ADDENDUM NO. 04 (MEPT)

Date of Issuance: April, 23, 2026

Project: **Replacement Elementary on Mustang Rd.**
Alvin Independent School District

Texas Arcadis Inc.
Project No.: 202502 - 30268973

1 ENLARGED PLAN - KITCHEN
1/4" = 1'-0"

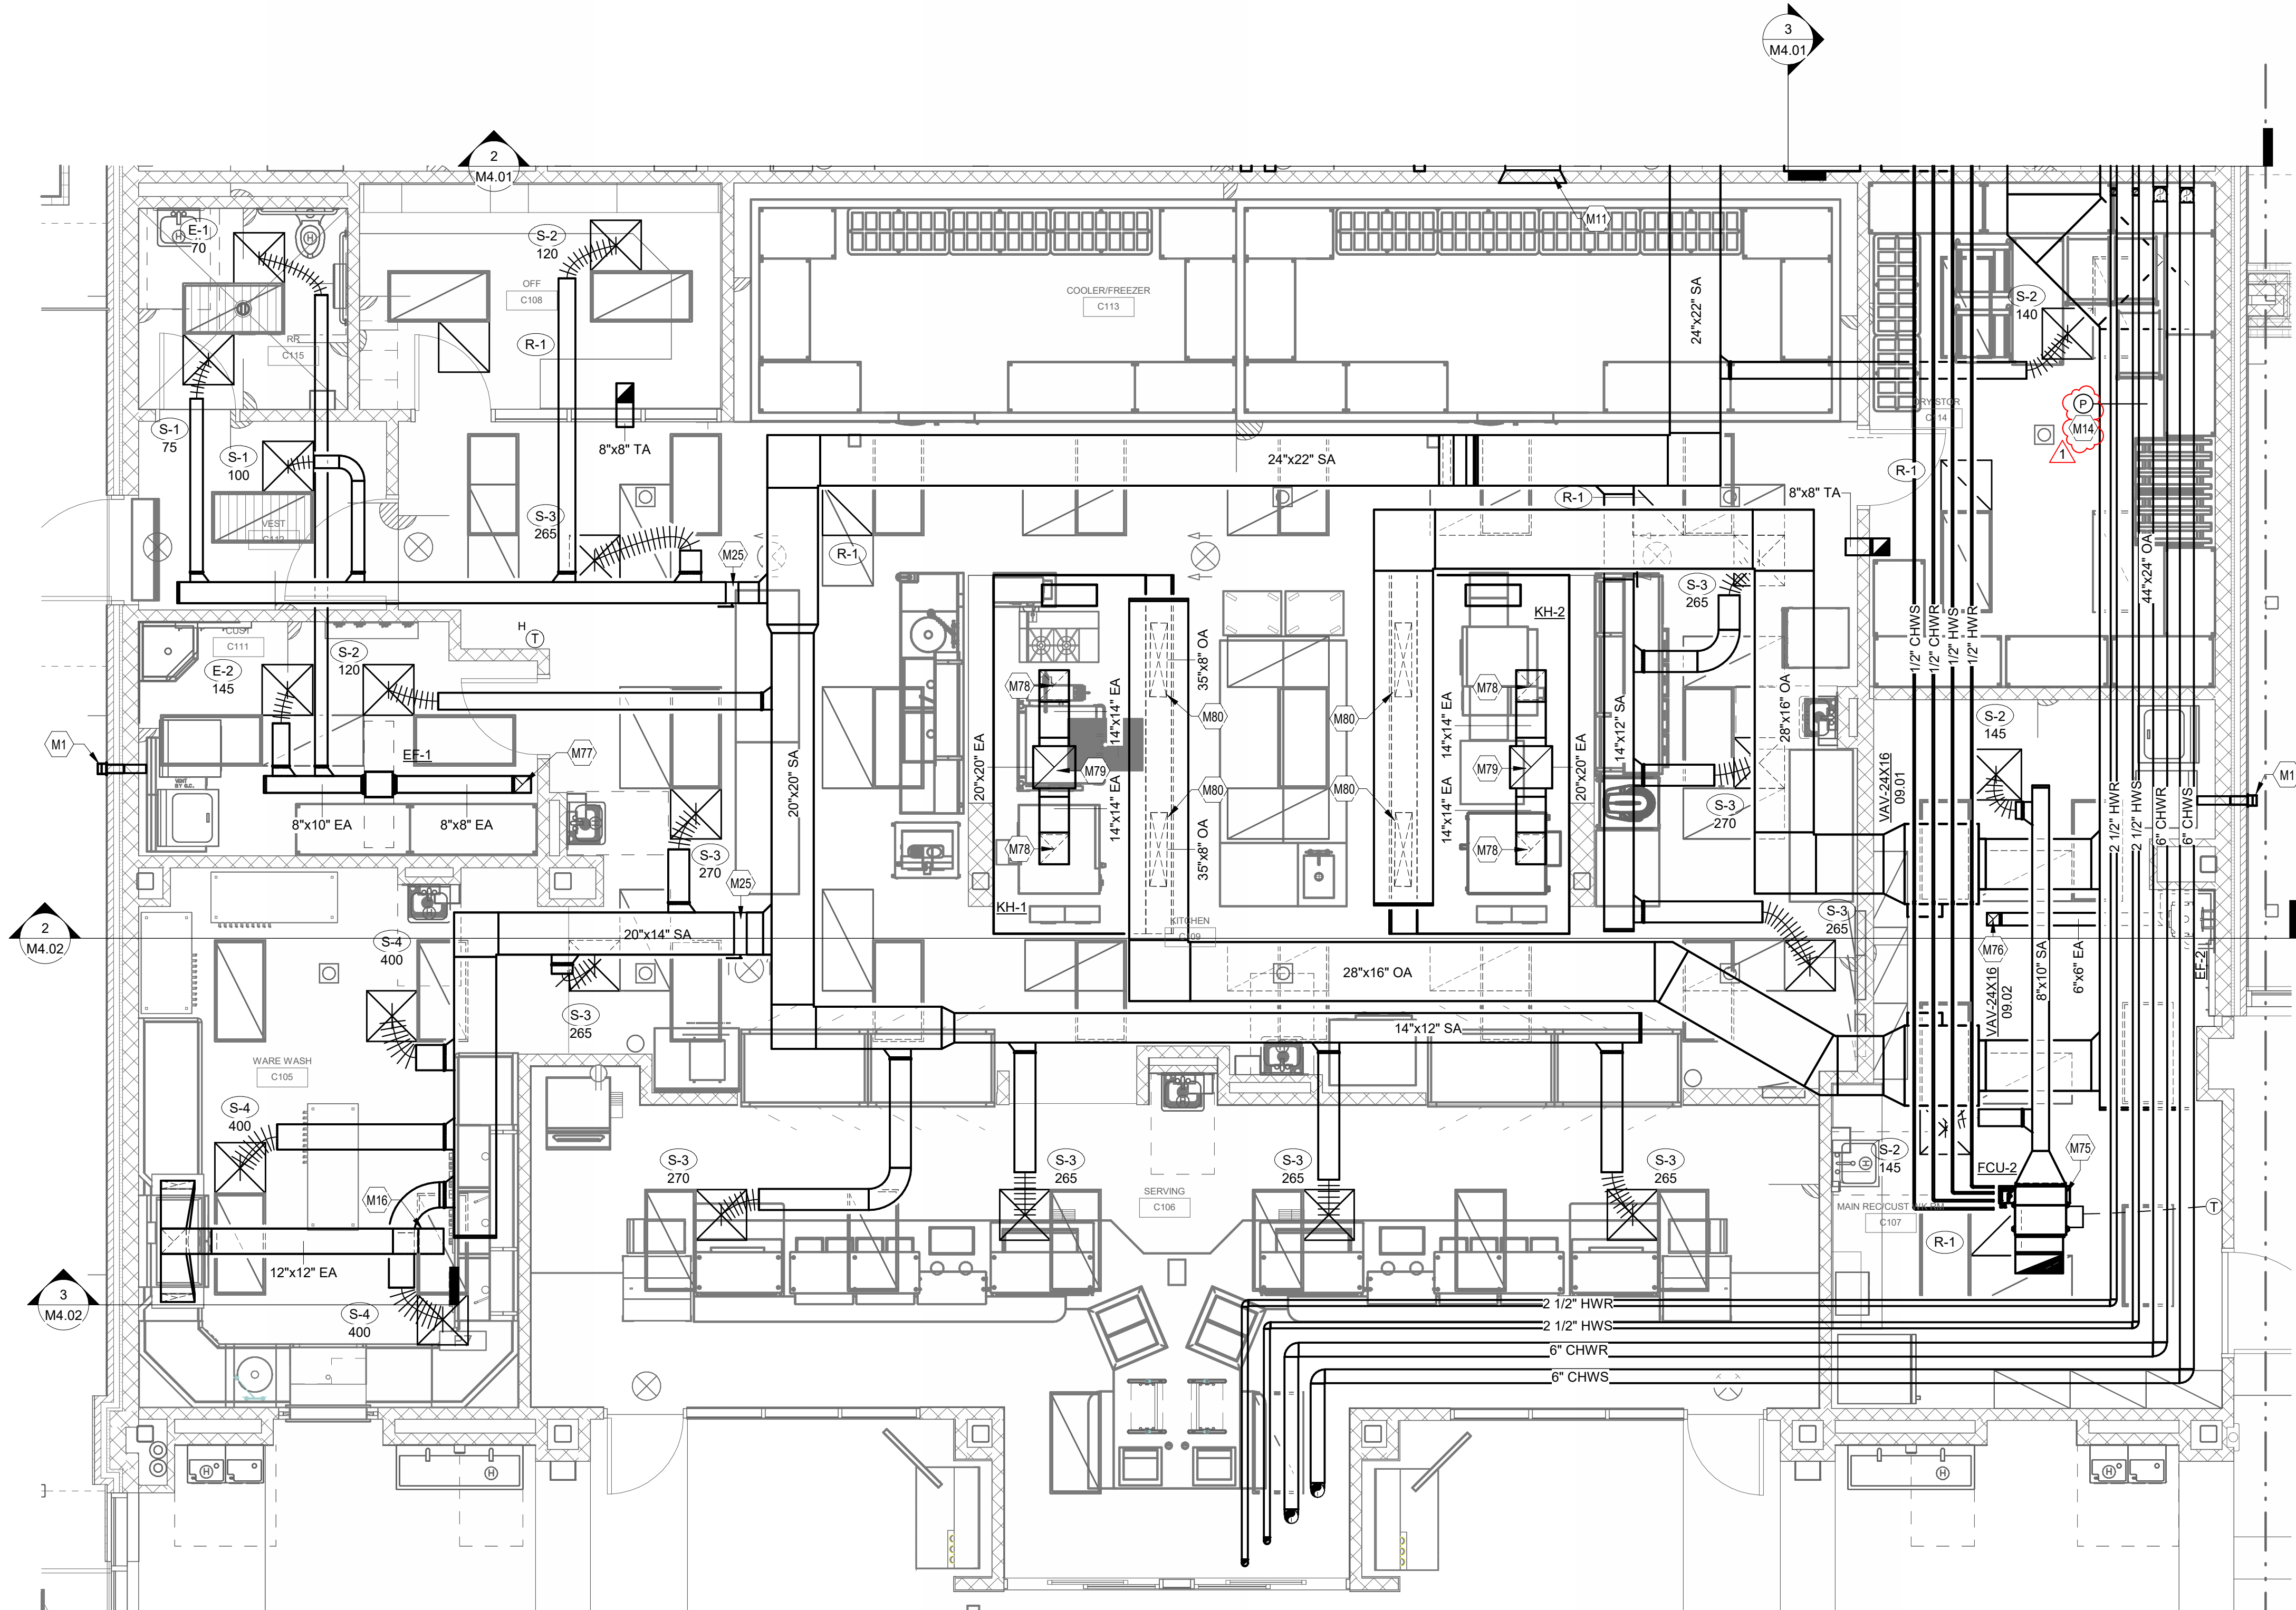
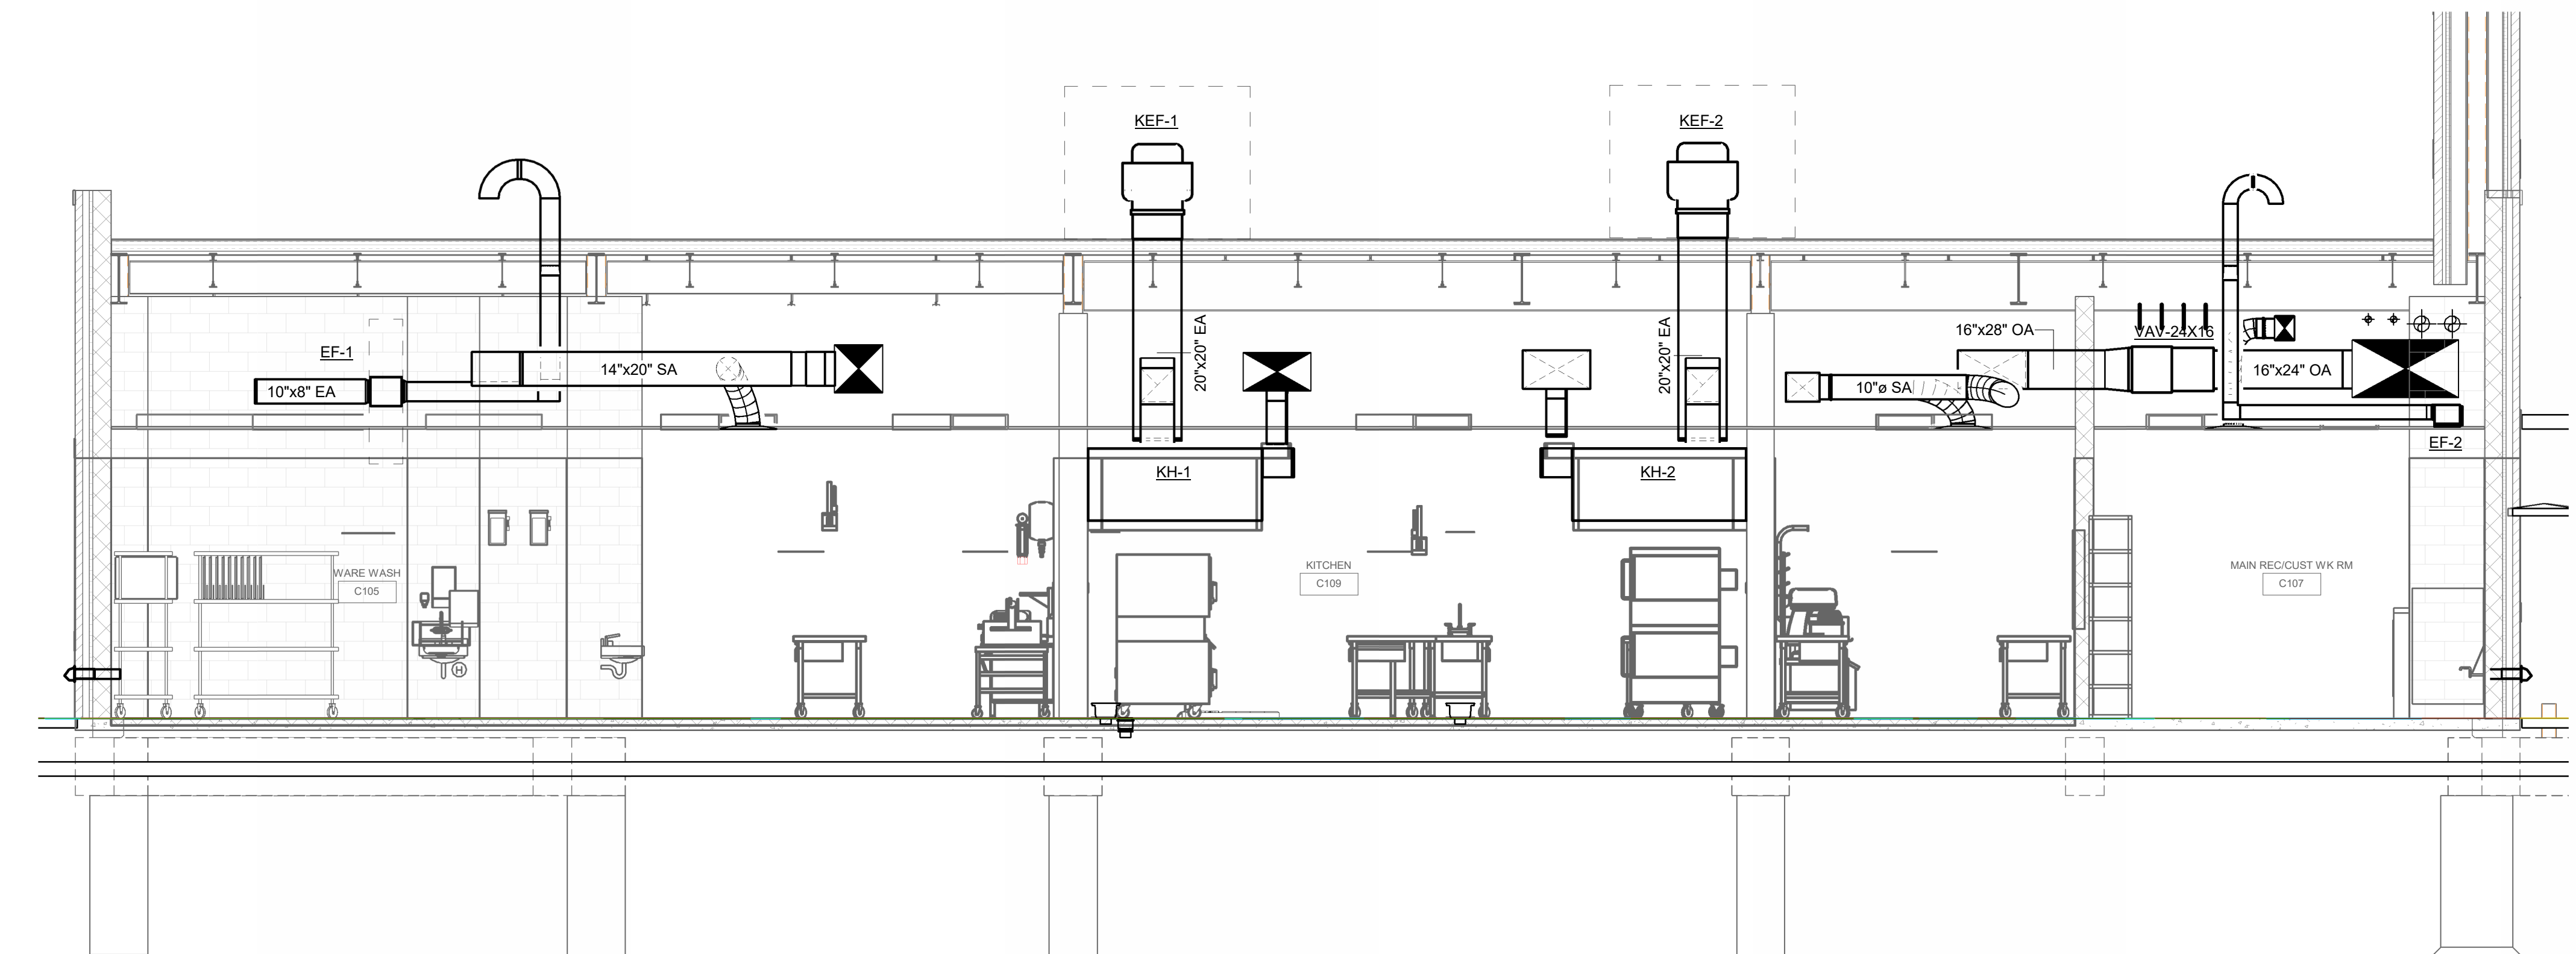
43. Sheet M4.02 – ENLARGED MECHANICAL ROOM – KITCHEN
 - a. Provided location for Duct Pressure sensor.
44. Sheet M4.05 – ENLARGED MECHANICAL ROOM – SECOND FLOOR
